Access Compliance Report
Public Rights-of-Way
(Curb Ramps)

Main Street: CHAPMAN_AVE | **Cross Street:** BEACH_BLVD | **Location:** SE

ADA ID: RPAT211130123621 | **Ramp Type:** Type 4 - Parallel | **Initial Pass/Fail:** Fail | **Overall Compliance:** No | **Severity Score:** 45

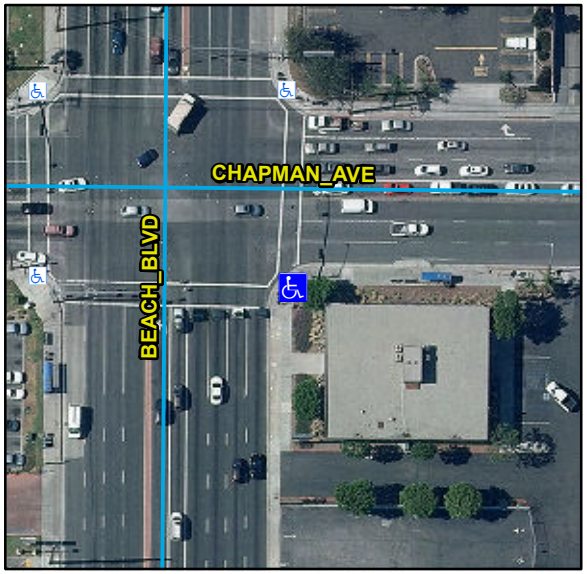
Compliance	Description	Data	Compliance	Description	Data
N/A	Ramp Length LT (in)	52	N/A	Ramp Length RT (in)	68
Yes	Ramp Width LT (in)	85	Yes	Ramp Width RT (in)	72
No	Ramp Run Slope LT (%)	11.3	No	Ramp Run Slope RT (%)	9.5
No	Ramp Cross Slope LT (%)	8.8	No	Ramp Cross Slope RT (%)	10.1
N/A	Landing Present	N/A	N/A	DWS Provided	N/A
N/A	Landing Length (in)	N/A	N/A	DWS Contrast	N/A
N/A	Landing Width (in)	N/A	N/A	DWS Length (in)	N/A
N/A	Landing Run Slope (%)	N/A	N/A	DWS Full Width	N/A
N/A	Landing Cross Slope (%)	N/A		DWS Offset Type	N/A
N/A	Landing Movement Obstructed?	N/A	N/A	DWS Offset Left (in)	N/A
	Landing Movement Type	N/A	N/A	DWS Offset Right (in)	N/A
N/A	Landing Shared	N/A			
N/A	Clear Space	Yes			
N/A	Clear Space To Crosswalk (in)	48			
N/A	Marked Crosswalk 1	Yes	N/A	Marked Crosswalk 2	Yes
	Crossing 1 Direction	N		Crossing 2 Direction	W
	Marked Crosswalk 1 Width (in)	120		Marked Crosswalk 2 Width (in)	120

Remove & Replace Curb Ramp With Two New Directional Ramps or Equivalent.

R304.3.2, R304.5.3, STD 1115
